# EIGHTEEN SUNSET

DESIGN REVIEW BOARD

FINAL SUBMITTAL JANUARY 4, 2021

DESIGN REVIEW BOARD *PROPOSED*

**SITE PLAN PROPOSED**

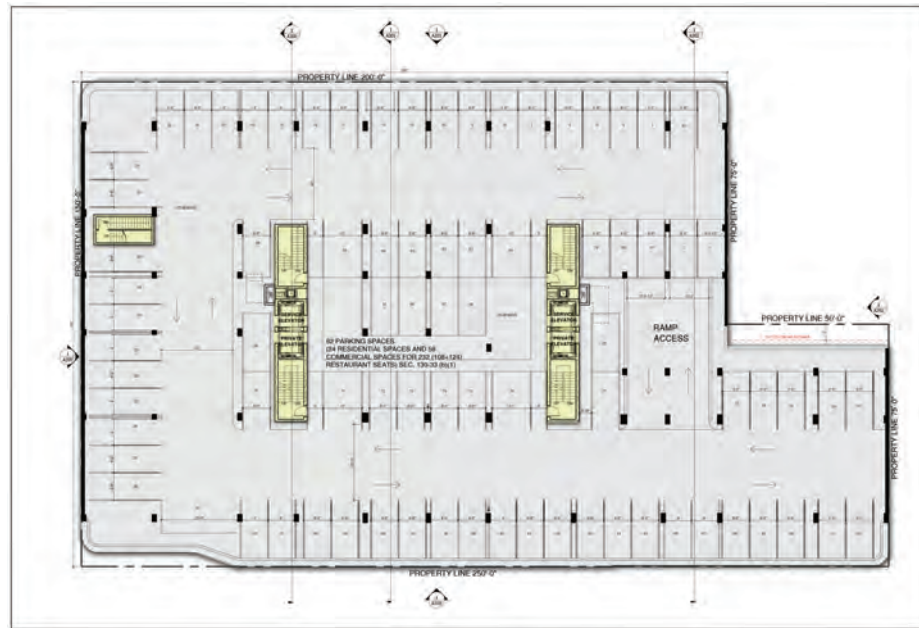
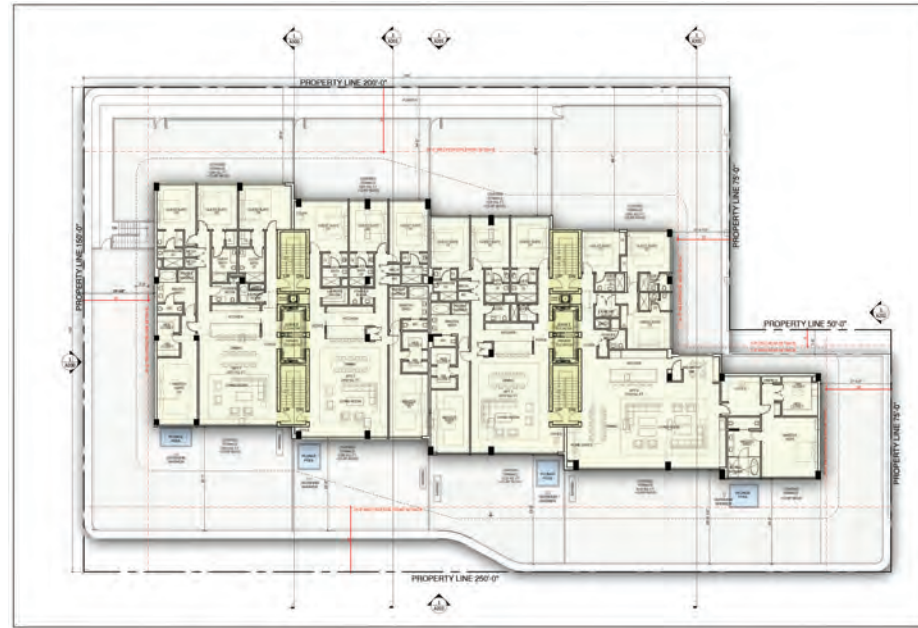
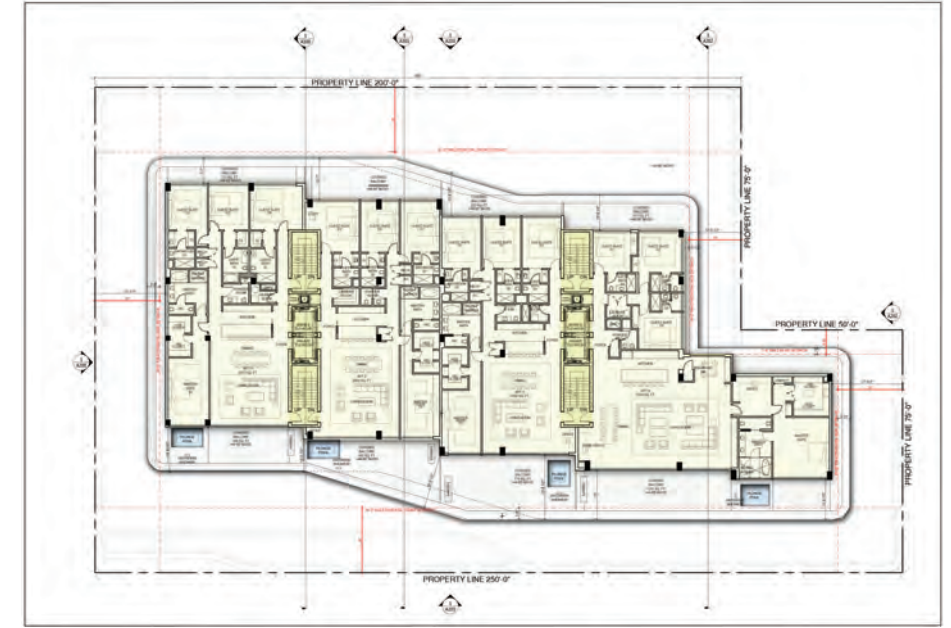
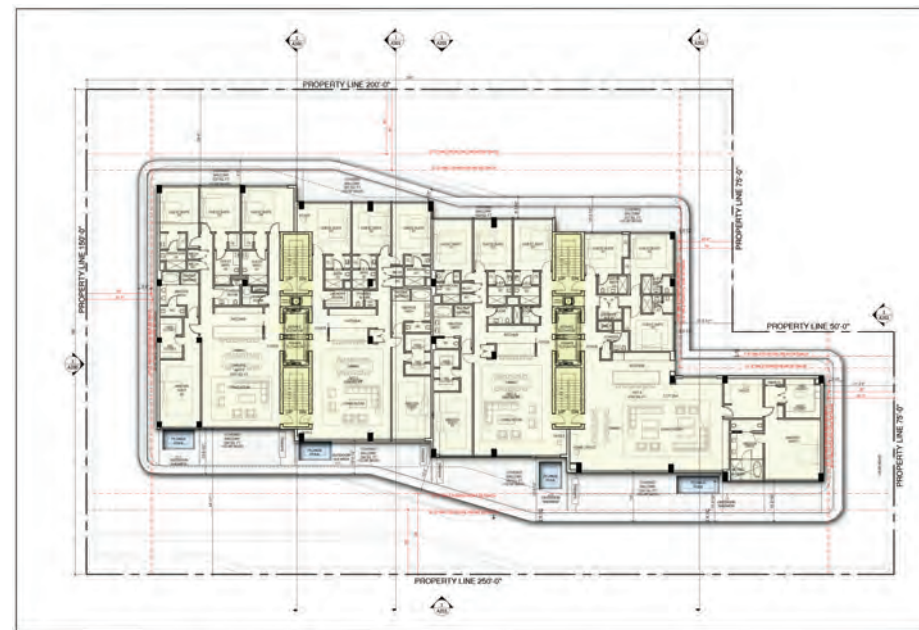
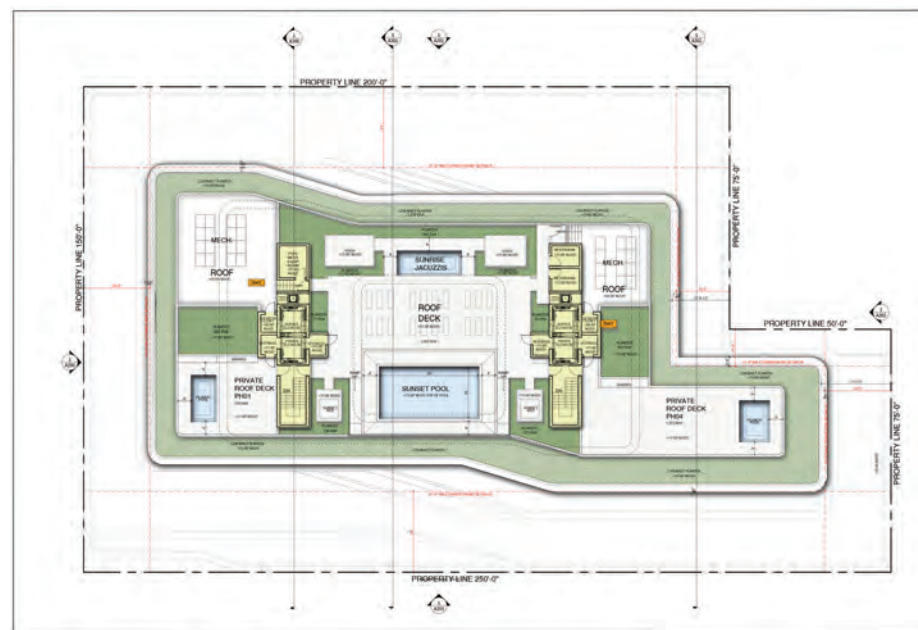
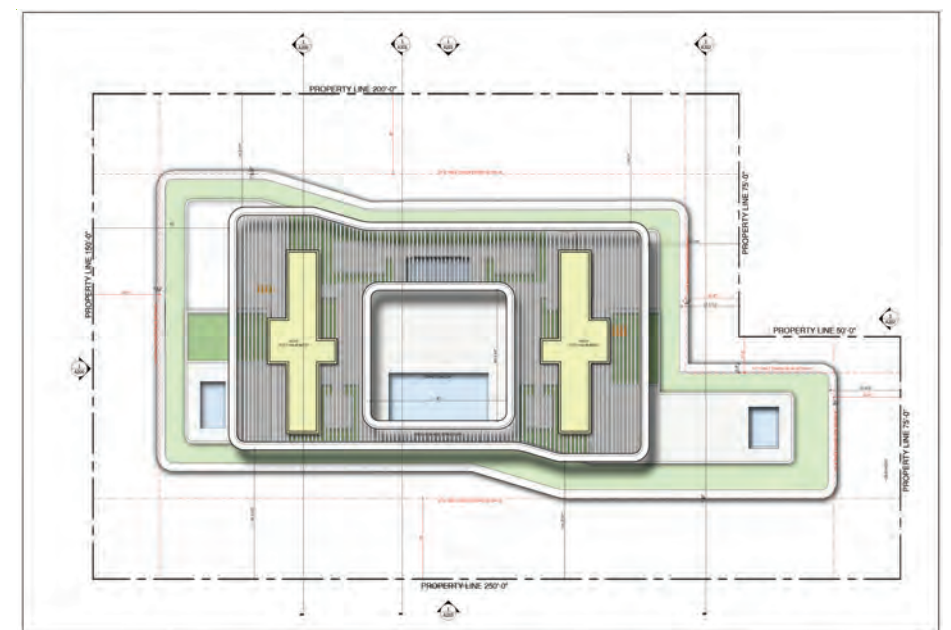
**NOTE A:**  
 CHANGES TO BE APPROVED ADMINISTRATIVELY. NOT PART OF THIS APPLICATION.

A) GLAZING PUSHED BACK 8'-0" FROM BAY RD.

B) LOCATION OF GARAGE RAMP AND LOADING DOCK FLIPPED.

C) GLAZING PUSHED BACK 10'-0" FROM PURDY RD.

D) RELOCATION OF STAIR AND ELEVATOR CORES.

F) ROOF POOL RELOCATED.

# UPPER FLOOR PLANS PROPOSED

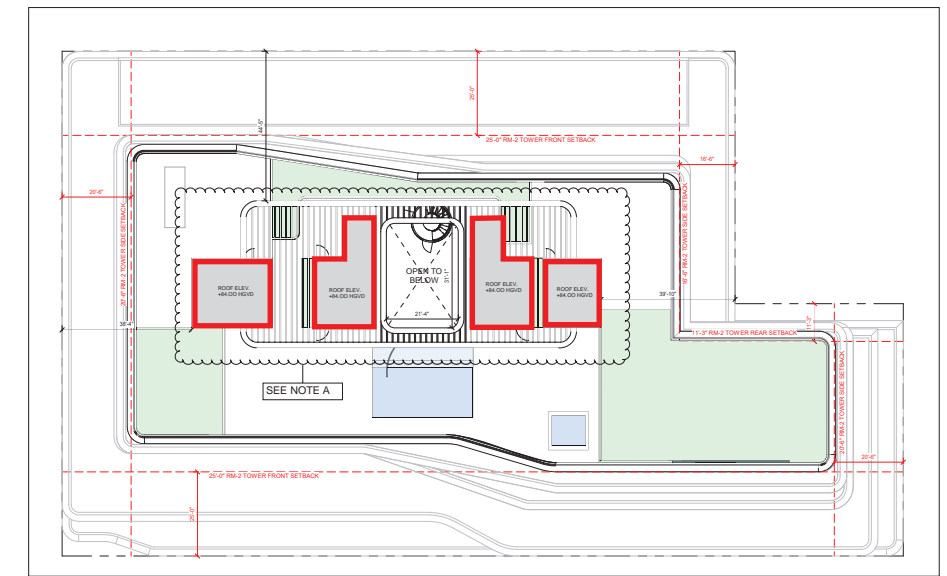
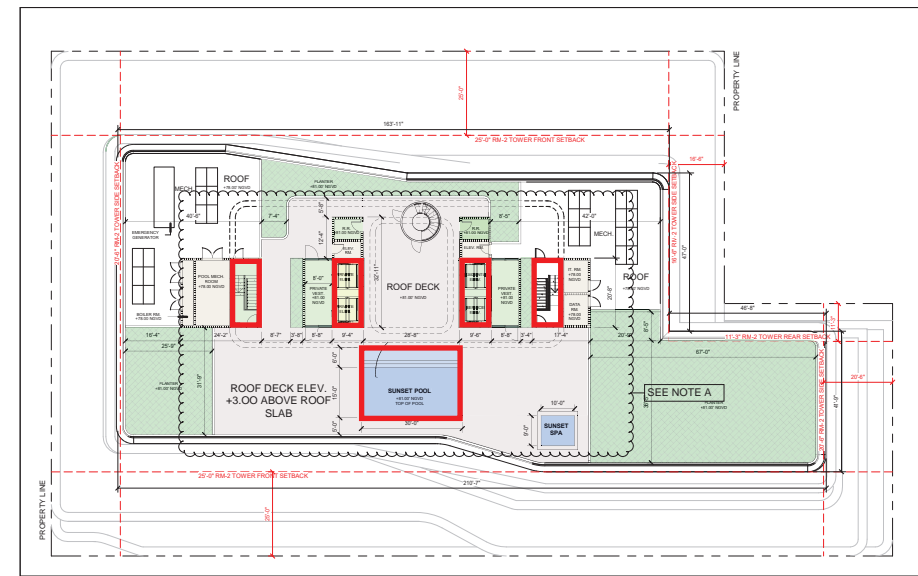
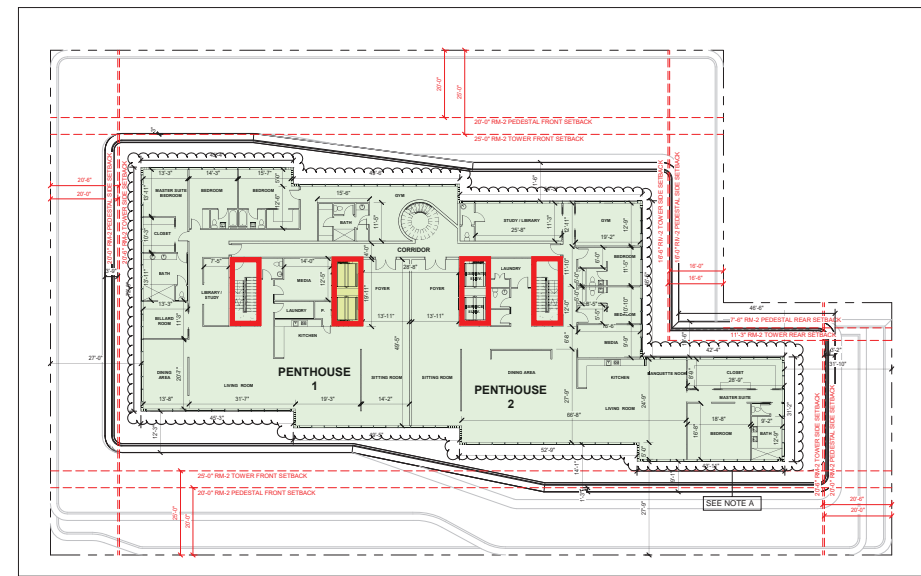
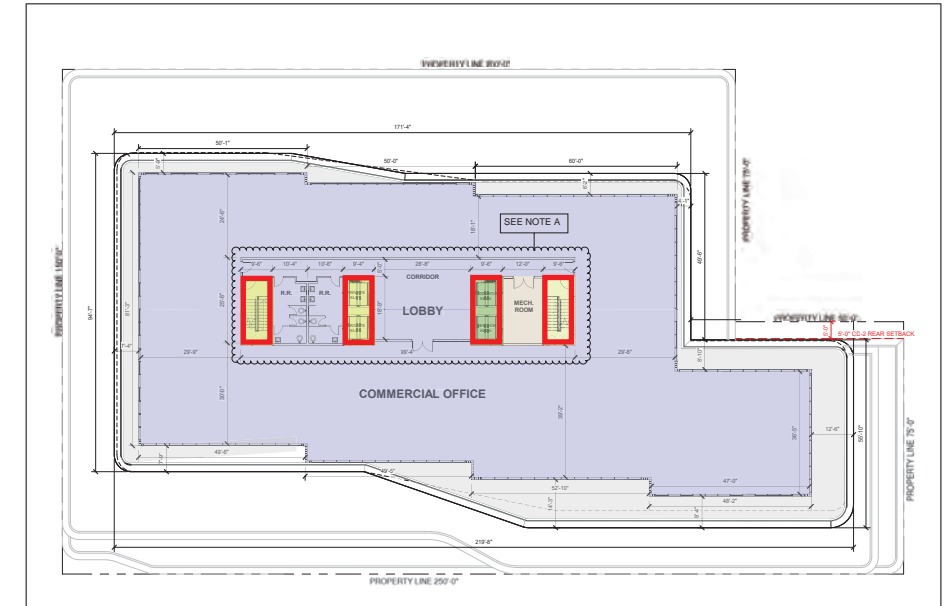
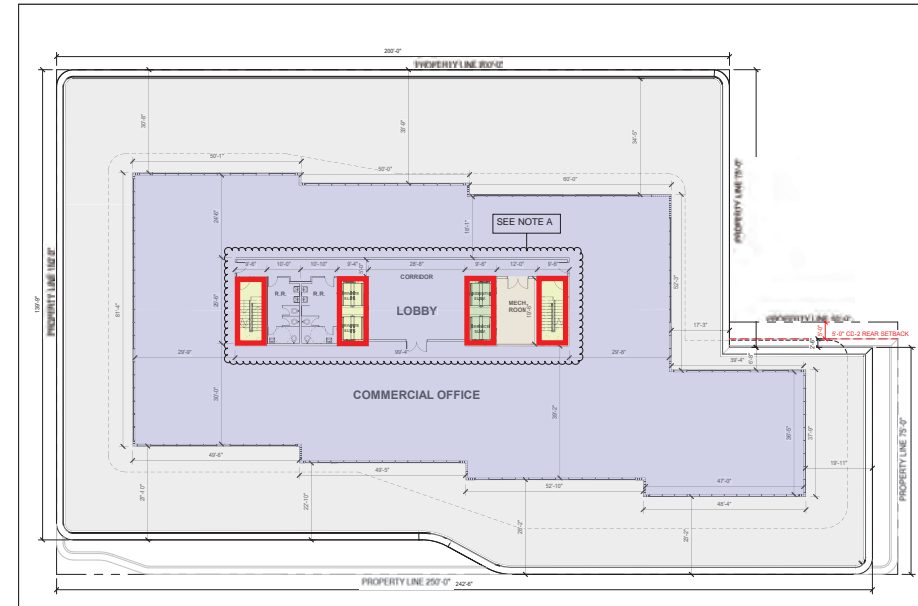
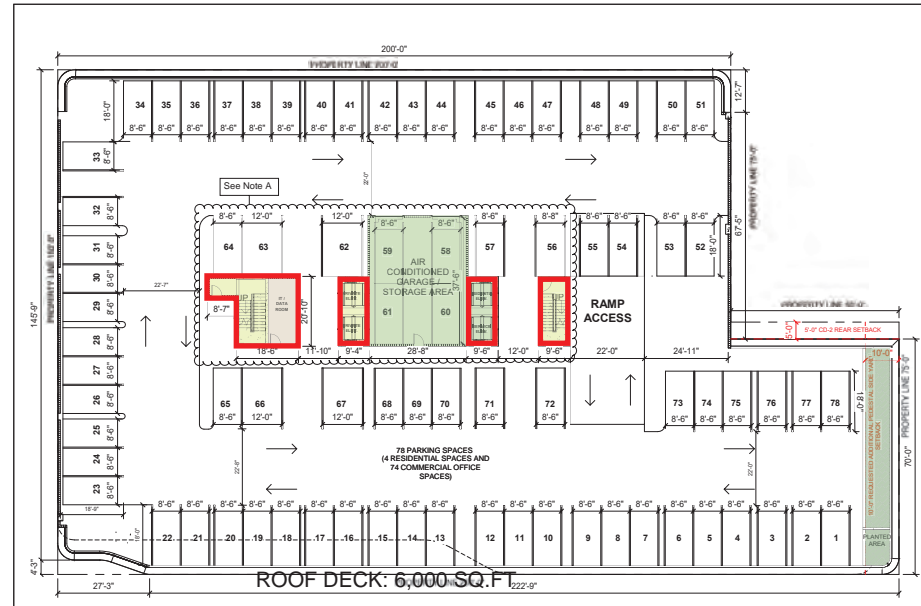
**NOTE A:**  
 CHANGES TO BE APPROVED ADMINISTRATIVELY. NOT PART OF THIS APPLICATION.

A) GLAZING PUSHED BACK 8'-0" FROM BAY RD.  
 B) LOCATION OF GARAGE RAMP AND LOADING DOCK FLIPPED  
 C) GLAZING PUSHED BACK 10'-0" FROM PURDY RD.  
 D) RELOCATION OF STAIR AND ELEVATOR CORES  
 E) ROOF POOL RELOCATED  
 F) ROOF POOL RELOCATED
